Upper Silver Creek Restoration Project Year 4 Monitoring Report

NCDMS Project ID Number – 94645

**Burke County, North Carolina
NCDMS Project ID Number – 94645**

Subject: Response to DMS comments on the Year 4 Monitoring Report Review for the Upper Silver Creek Stream and Wetland Restoration Project; Catawba River Basin - CU# 03050101; Burke County, North Carolina; NCEEP Project # 94645; Contract No. 003270

Figure 7. Longitudinal Profiles with Annual Overlay

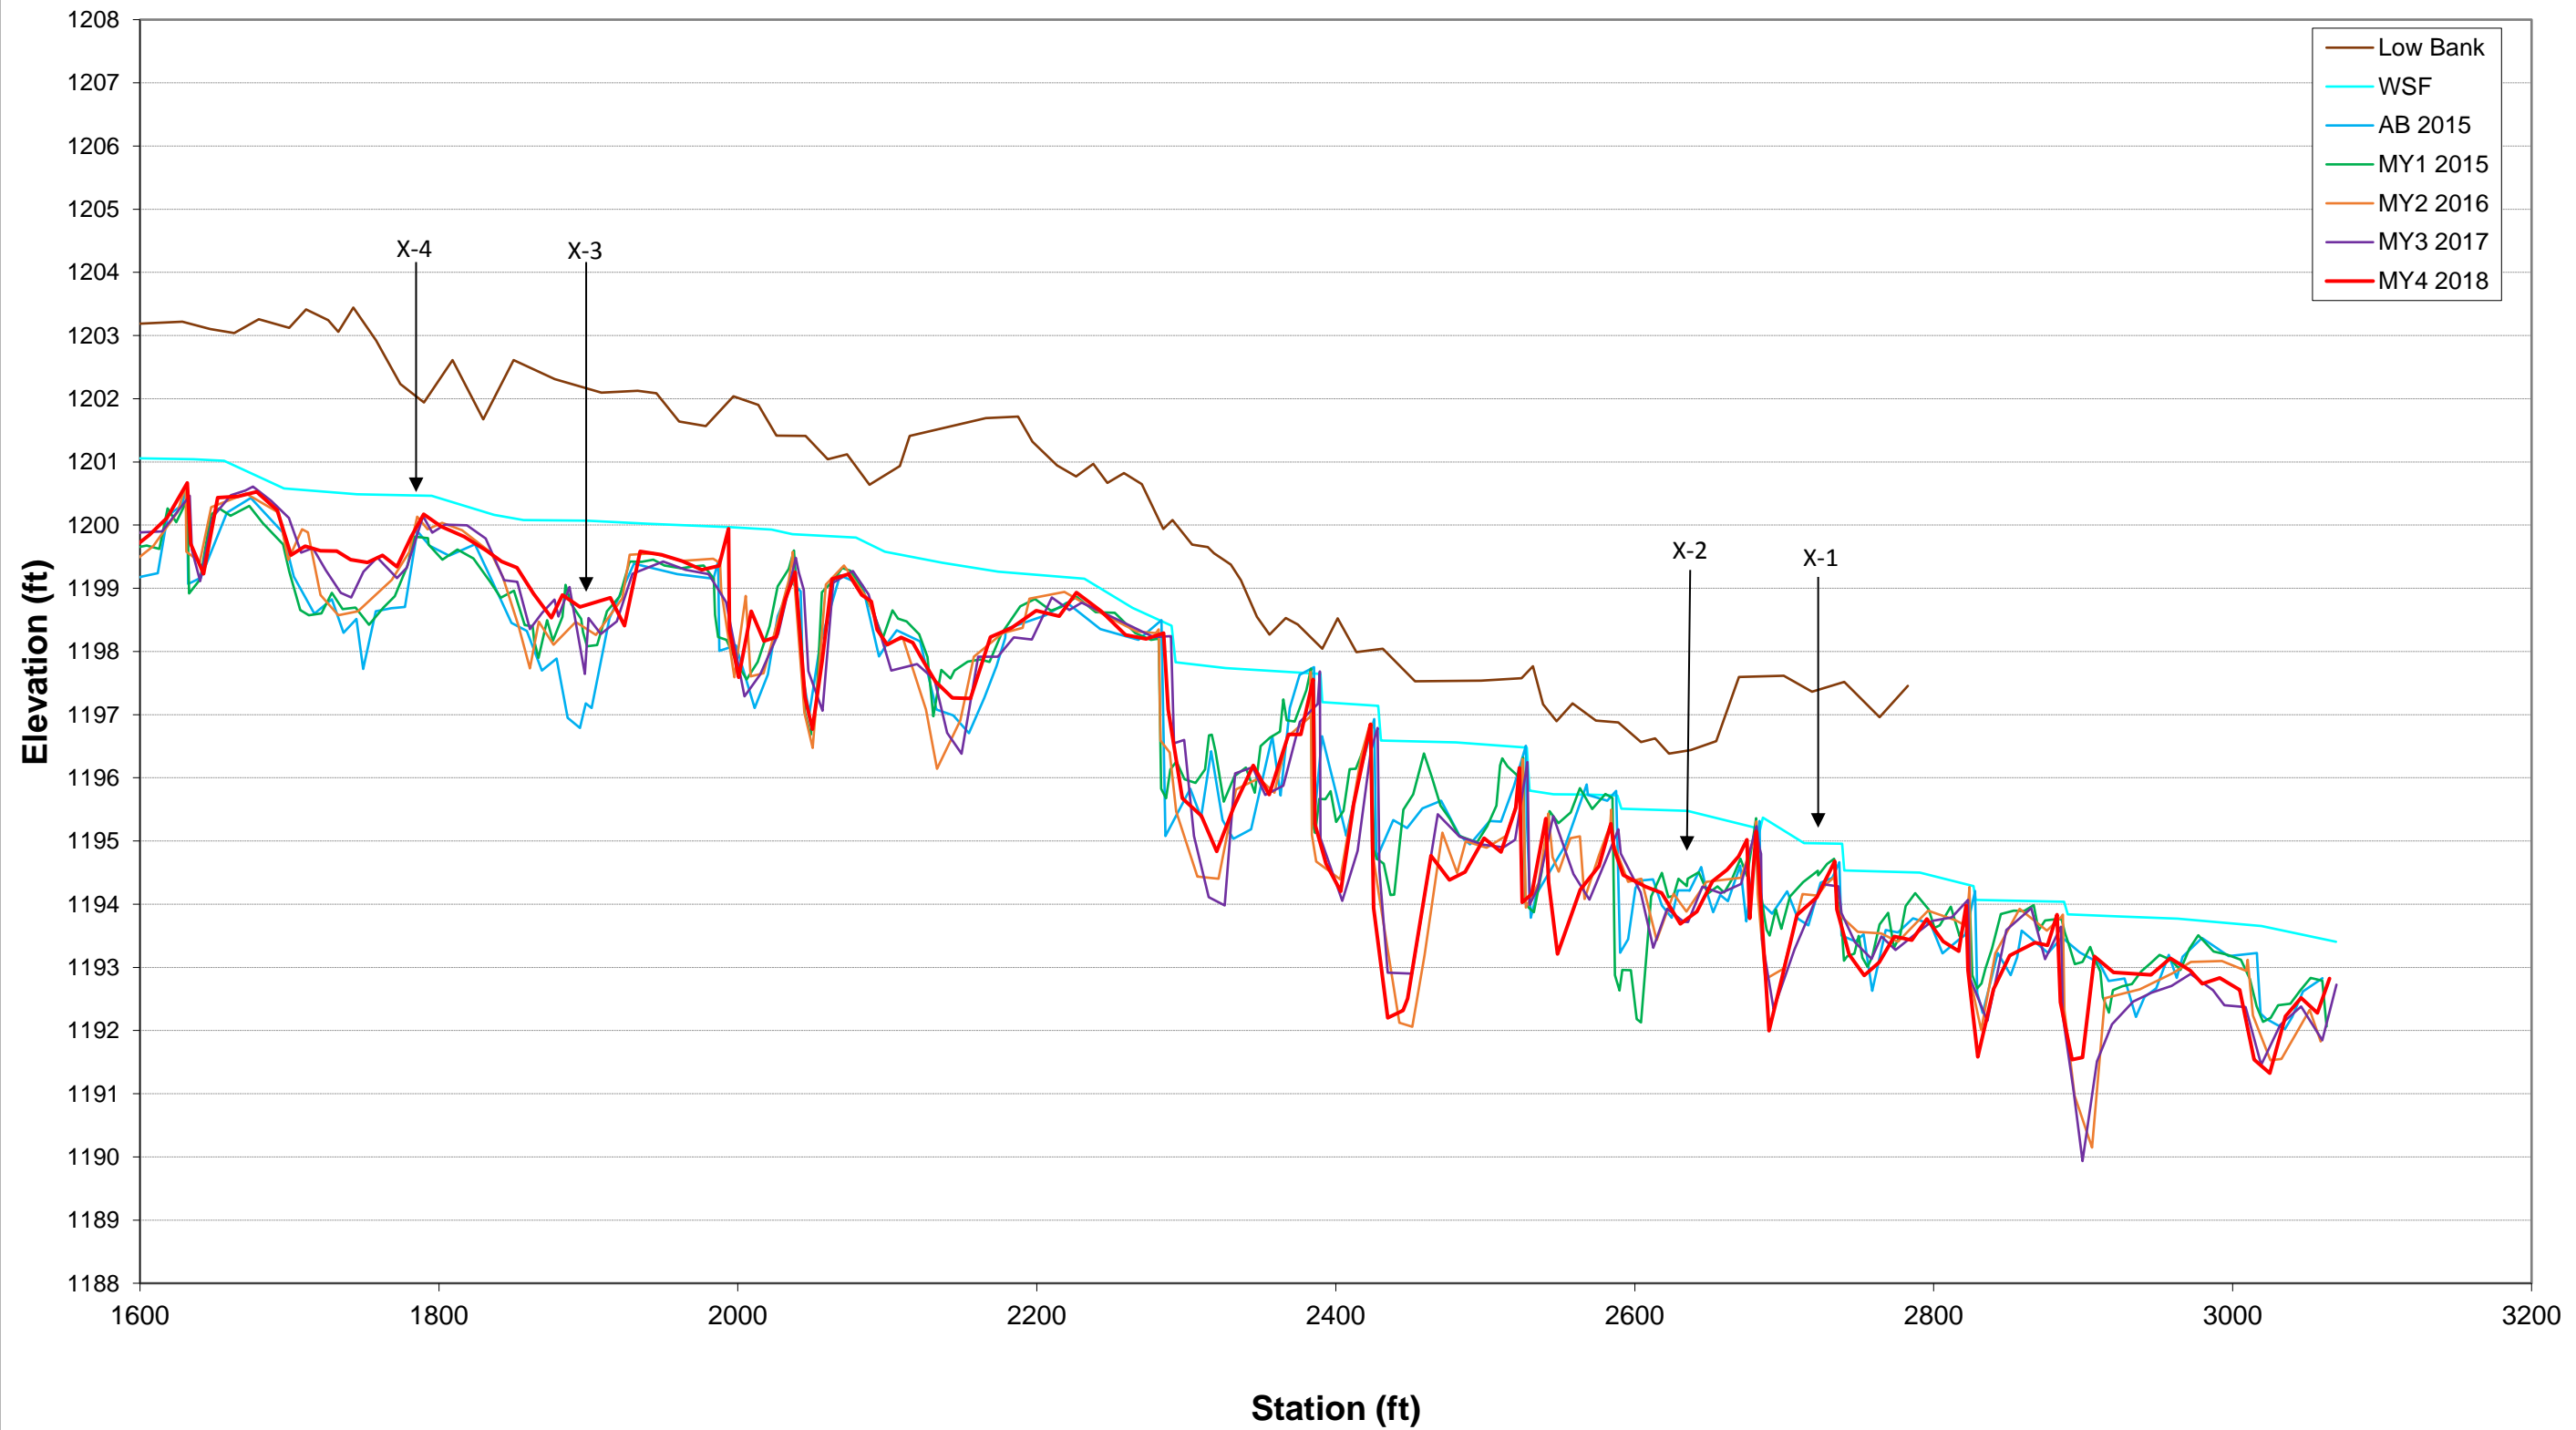
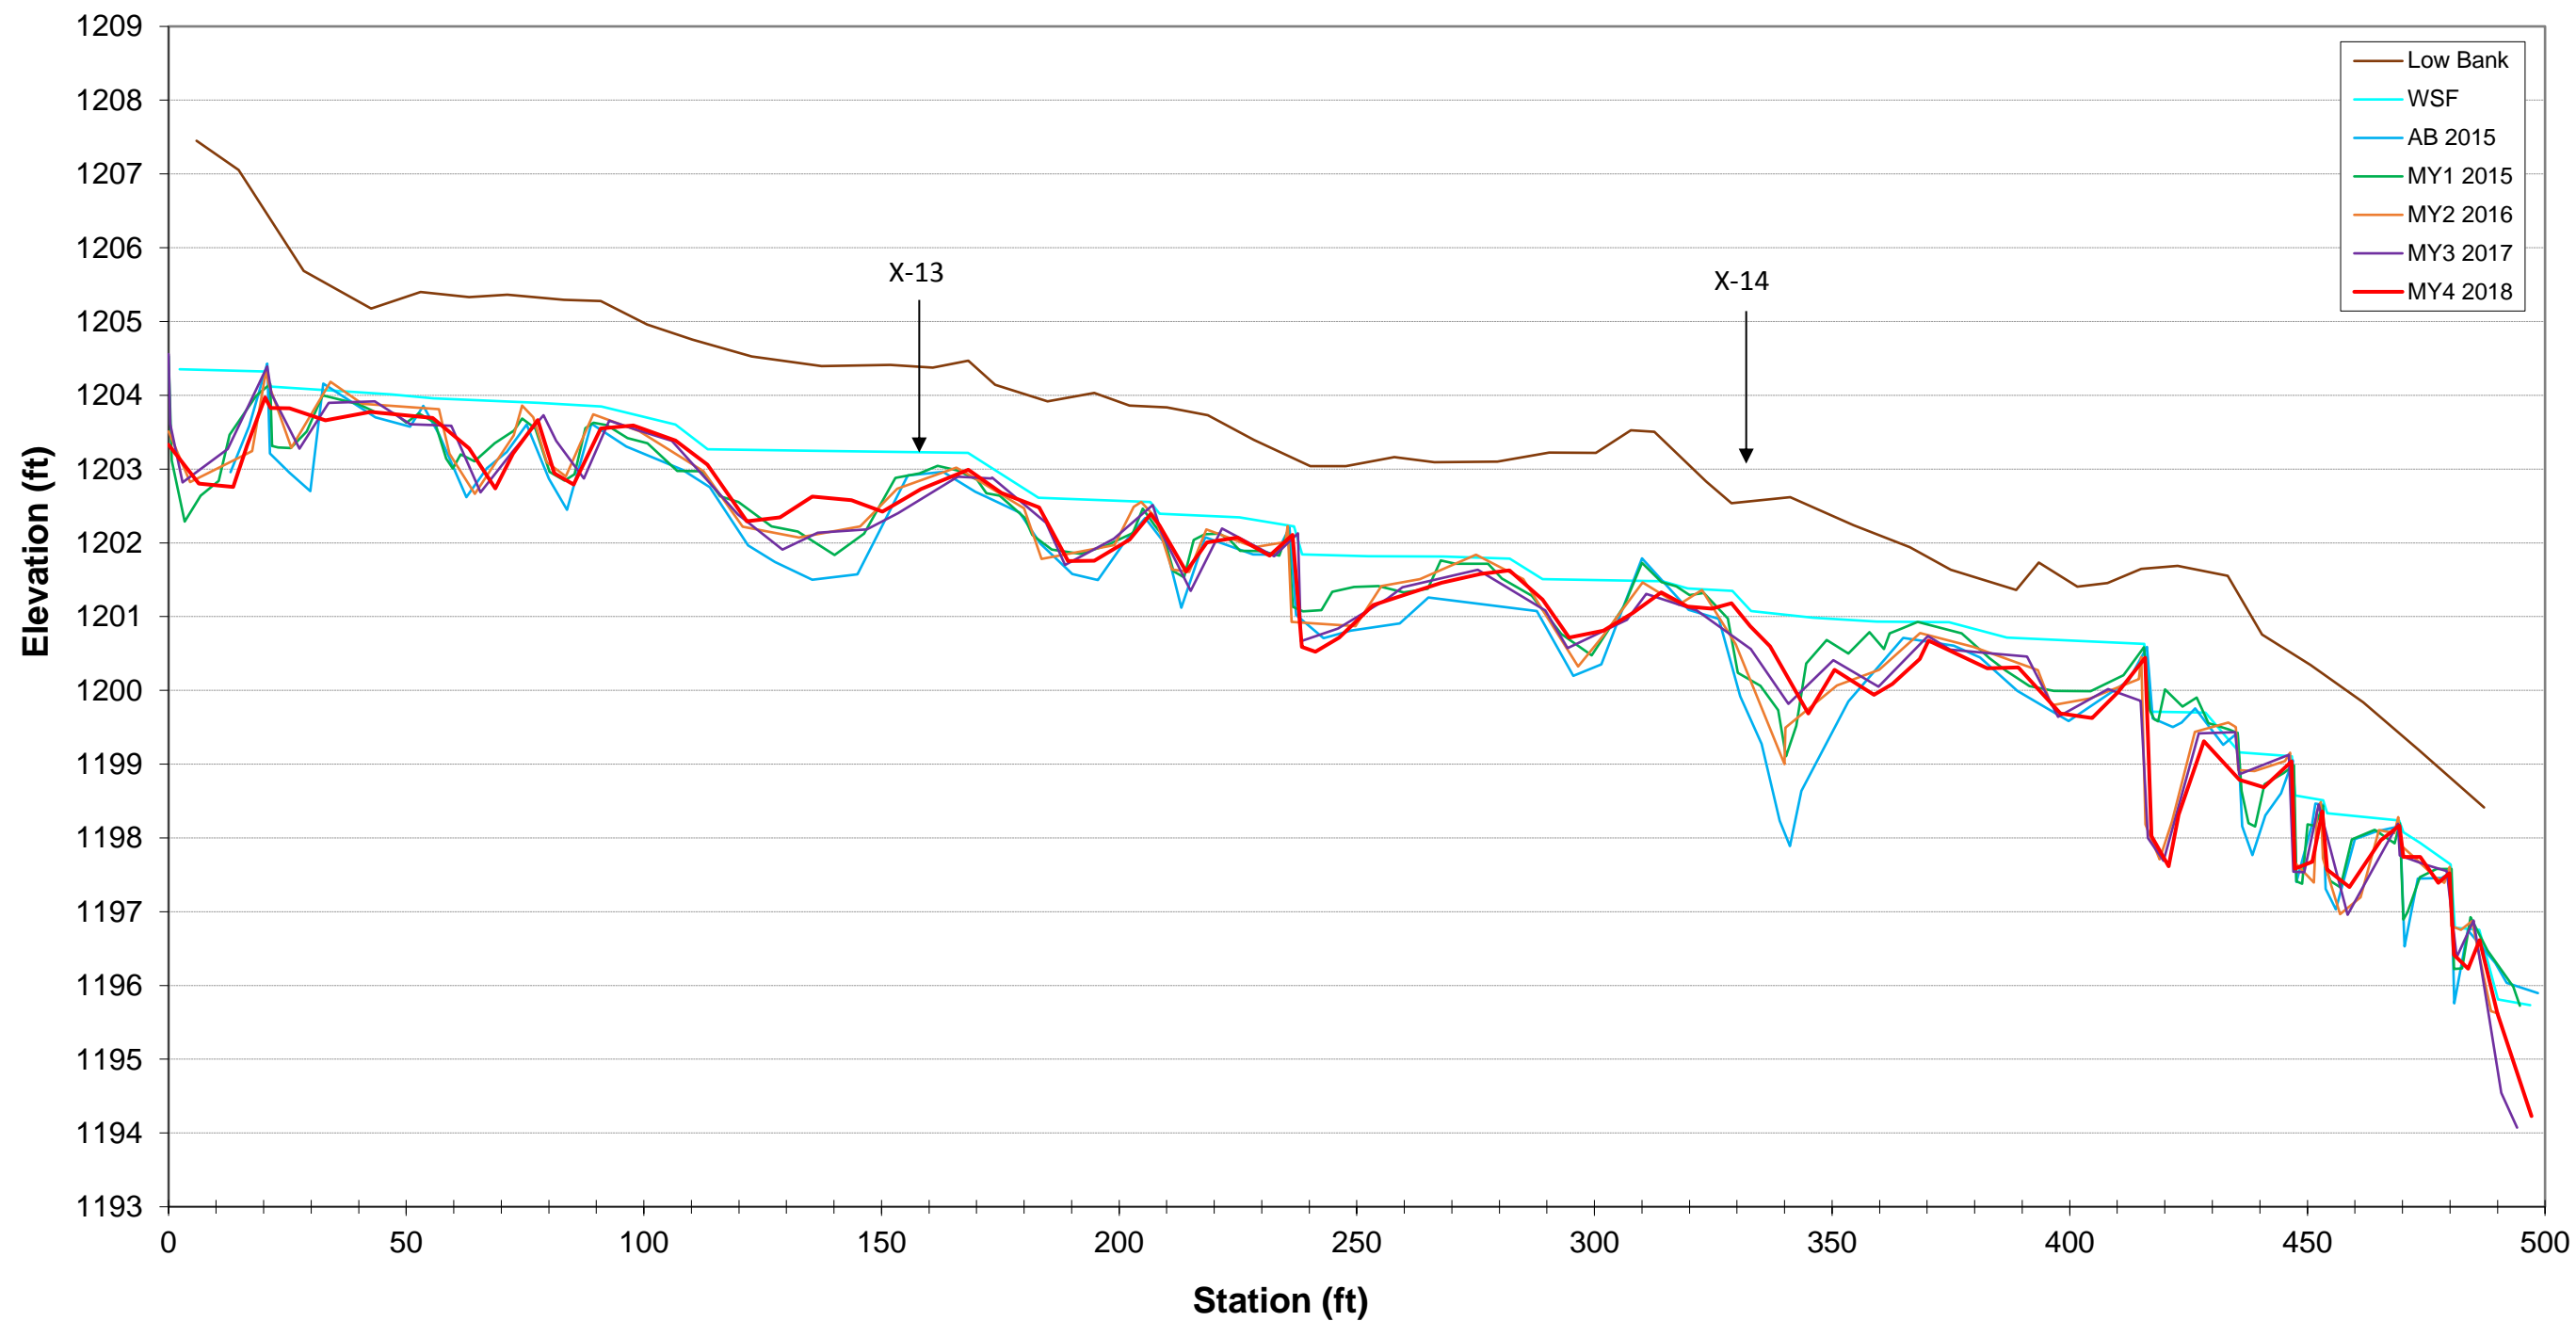
- The UT2 profile and sections of UT3 indicate significant aggradation. As Baker is aware, the USACE will be looking at defined bed/bank and often denies credit for channels that have become filled with sediment. I am aware of the large upstream sediment sources from past mining activities on UT2. Please add a short discussion in section 2.2.1 regarding this issue. Does Baker have any corrective action or adaptive management planned for these reaches?

We have added more information to the discussion of aggradation in section 2.2.1. We do indicate that we will monitor the areas of aggradation indicated by the cross-sections and general project channels, to be sure that sandy material that has moved into the project reach due to the unusually high flows of this year, is moving through the system. We will specifically evaluate UT2 and areas of UT3 to evaluate ways that we can enhance sediment transport or directly remove accumulated sediment as needed. In some locations this likely will involve removal of vegetation (cattails) or woody debris that is causing aggradation.
